ACCESSION NBR: 9512010263 DOC. DATE: 95/11/27 NOTARIZED: NO DOCKET #
 FACIL: 50-244 Robert Emmet Ginna Nuclear Plant, Unit 1, Rochester G 05000244
 AUTH. NAME AUTHOR AFFILIATION
 MECREY, R.C. Rochester Gas & Electric Corp.
 RECIPIENT NAME RECIPIENT AFFILIATION
 JOHNSON, A.R.

SUBJECT: Forwards request for addl info re conversion to improved TS for pressurizer safety valve tolerance.

Subject: Conversion to Improved Technical Specifications
Pressurizer Safety Valve Tolerance
R.E. Ginna Nuclear Power Plant
Docket No. 50-244

Attachment A
Response to RAI for Pressurizer
Safety Valve Tolerance Change

**Figure 4.3-9
Loss of Load, Minimum Feedback
Without Pressure Control
Steam Generator Pressure and
RCS Pressures Versus Time**

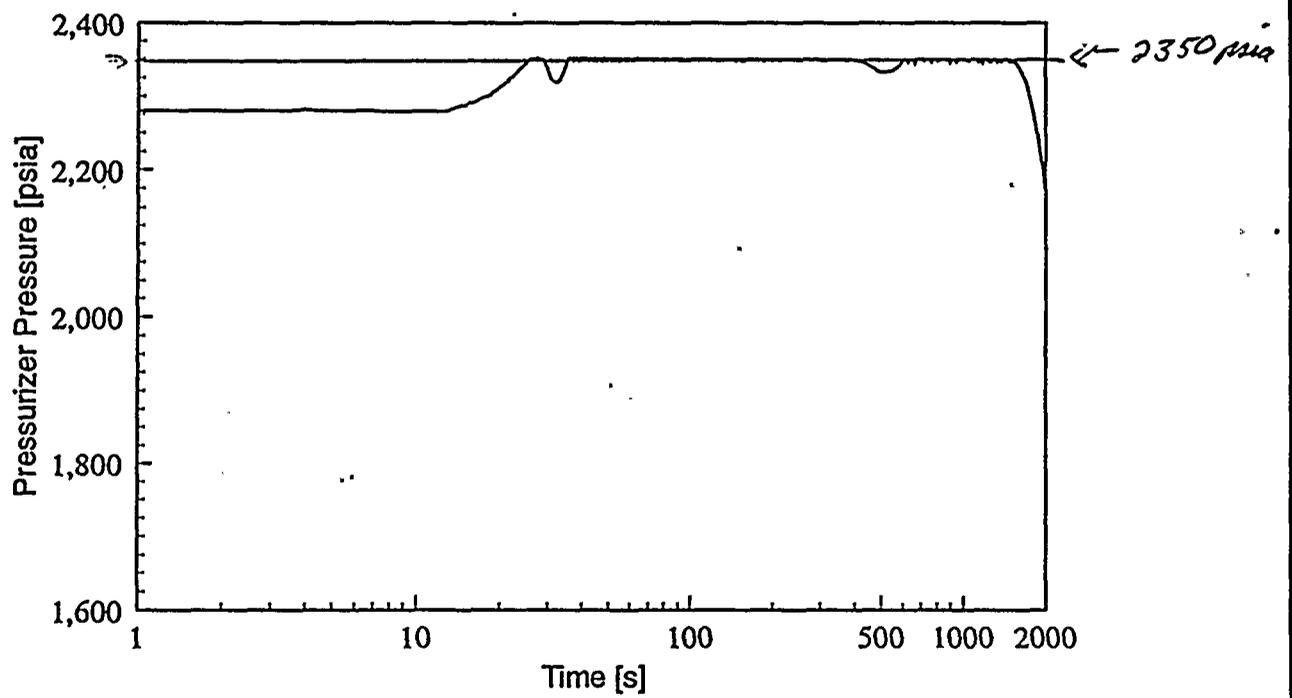
4. Demonstrate that for a peak pressure evaluation the feedline break transient is bounded by the loss of load/turbine trip event.

The peak pressure evaluation for feedline break is bounded by the loss of load/turbine trip event. This can be seen from the attached figures.

Figure 4.3-9 illustrates pressurizer pressure versus time for a loss of load/turbine trip. As can be seen the rate of pressure rise is high. The pressurizer safety valve setpoint used in this analysis is 2585 psia. No credit is taken for pressurizer PORVs. The rate of pressure rise is great enough to cause the setpoint to be overshoot with the peak pressurized

pressure being greater than 2600 psia.

If the feedline break transient was modeled using the pressurizer safety valves versus the PORVs the pressure would increase to the safety valve setpoint (2585 psia) without any overshoot. Since the capacity of the safety valves is larger than the capacity of the PORVs and there is no overshoot of the PORV setpoint there would not be an overshoot of the safety valve setpoint. Because of the setpoint overshoot the loss of load/turbine trip event bounds the peak pressure of the feedline break event.

The evaluation done for Figures 4.3-9 and 4.6-6 is for the 18 Month Fuel Cycle with the new replacement SG(s). A similar evaluation was performed for the existing SG(s) however, illustrative figures were not generated. Only tabular results were generated to confirm the peak pressure criteria was not violated.
